September 17, 1984

SUBJECT: Peach Bottom Atomic Power Station
Fire Protection Modifications Progress Report

I. Modification Progress Report

PSD # 024

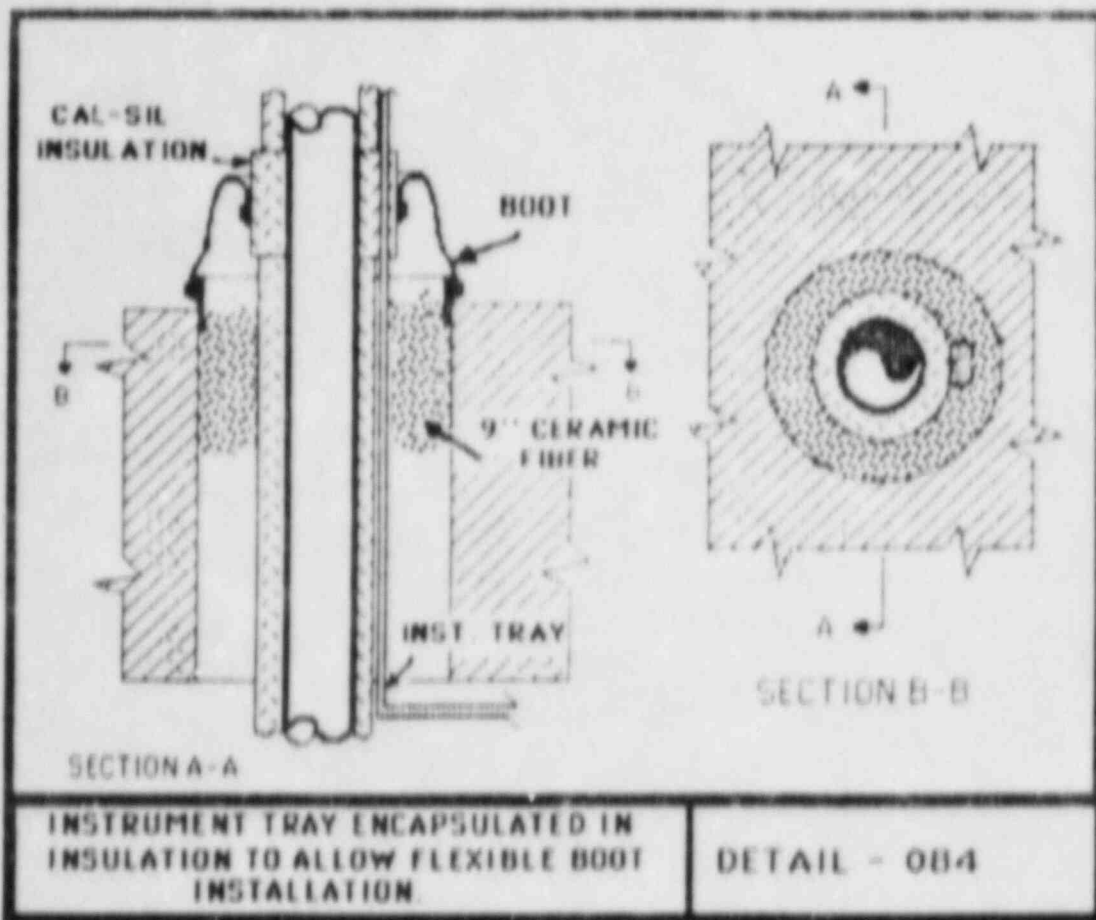
Location: Units 2 & 3 North & South Isolation Valve rooms Elevation
135'-0" floor penetrations (Rooms 203, 204, 248 and 249).
Condition prior to Upgrade:

all penetrations are sleeves containing a large insulated
pipe and an instrument tray penetrating the barrier. On
the 'A' side (isolation valve room) the instrument tray
Description of Upgraded Penetration Seal: (Pg. 2)

runs parallel and close to the pipe. On the 'B' side (torus room) close to the barrier, the instrument tray turns and runs perpendicular to the pipe preventing the installation of a flexible boot on this side.

On the 'A' side the instrument tray is encapsulated
in calcium-silicate insulation at the barrier to
allow the installation of a flexible boot on this side.
Justification: (Pg. 2)

The perimeter of the pipe insulation was built
up to encapsulate the instrument tray so that
the sealing ring area is tight without voids. This
is considered an acceptable seal since both sides
of the barrier are non hazardous with negligible com-
bustible loading (0.00 hrs both sides).

and 9" of ceramic fiber within the barrier. The 'B' side remains open. See detail 084.

PSD # 066

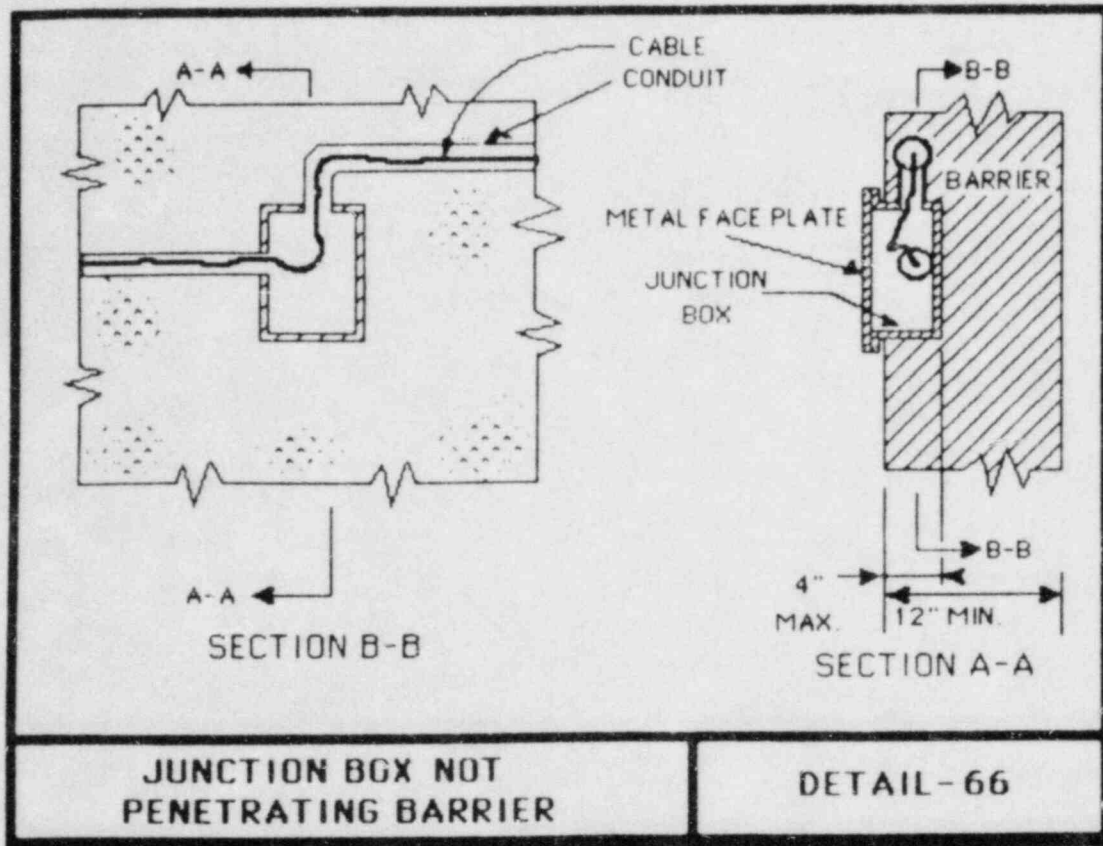
These items are junction boxes embedded in the wall containing conduits with or without cables. The junction boxes are embedded, but do not penetrate the wall.

The junction boxes are hermetically sealed. The conduits are also embedded in the barrier, and do not exit the fire barrier on the opposite side within a 5 foot radius of the point at which it enters the barrier.

No seal upgrade was required. See detail 066.

The conduits do not penetrate the barrier within a 5 foot radius of the barrier entry point, since the cabling (a combustible source) is in a conduit which

is embedded in concrete, it is not directly subjected to an open flame. Additionally, the chances that flaming material would be propagated through the barrier via a conduit during the application of a hose stream is considered negligible since the junction boxes are hermetically sealed which would prohibit the introduction of combustible materials internal to the junction boxes.

With the junction boxes being hermetically sealed and embedded within the barrier, smoke and hot gases are restricted from penetrating the barrier. The cabling located within the barrier does not present a significant smoke and hot ^{gas} hazard since it is isolated from open flames and insulated from the heat of the fire.

The concrete walls and floors will provide a heat sink for the conduit. Heat generated from a fire occurring on the conduit access side of the barrier transported into the conduit will be dissipated through the steel conduit wall into the heat sink. Temperature on the unexposed side of the barrier will not be significantly increased.

DETAIL - 69

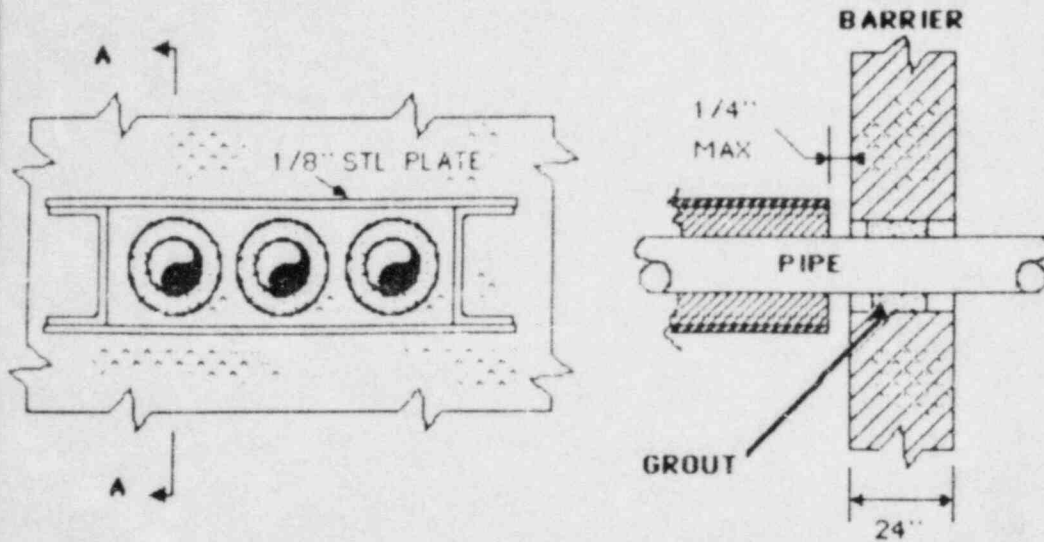
Cardox piping penetrating fire barriers, shrouded in steel plating. Penetrations are grouted at the barriers both sides. All pipes are 3" in 4" con boxes.

Because of the trays welded construction and the amount of time and effort which would be required to make the penetration available for sealing, an engineering evaluation was conducted. This review found the beginning of the pipe run (ESW booster pump bay north wall) and the last pipe pene- (P82.)

tration (E4 emergency diesel generator bay south wall) to be sealed in grout and in good condition. Additionally, portions of core bores in intermediate barriers were visible above the shrouding. These also were found to be sealed with grout.

No upgrade required. See detail 069.

Each diesel generator bay is separated by a 24 inch concrete barrier. The annular space around the penetrations of interest appear to be sealed full depth with grout. The steel plating tray or shroud surrounding these pipes, though not hermetically sealed, it is of such construction as to allow a minimal amount of flaming material to reach the barrier. Their location - high in the overhead - also makes the possibility of flaming material transport through the barrier remote. Additionally, passage of flaming material through the barrier at these penetrations when subjected to a hose stream is not considered probable since no direct hose stream path to the penetration exist. Although each diesel generator bay has a combustible loading of 0.63 hrs (38 minutes), for the reasons listed above, the existing seals are considered adequate. In addition, obviously each diesel generator is protected by a total flooding CO₂ system.
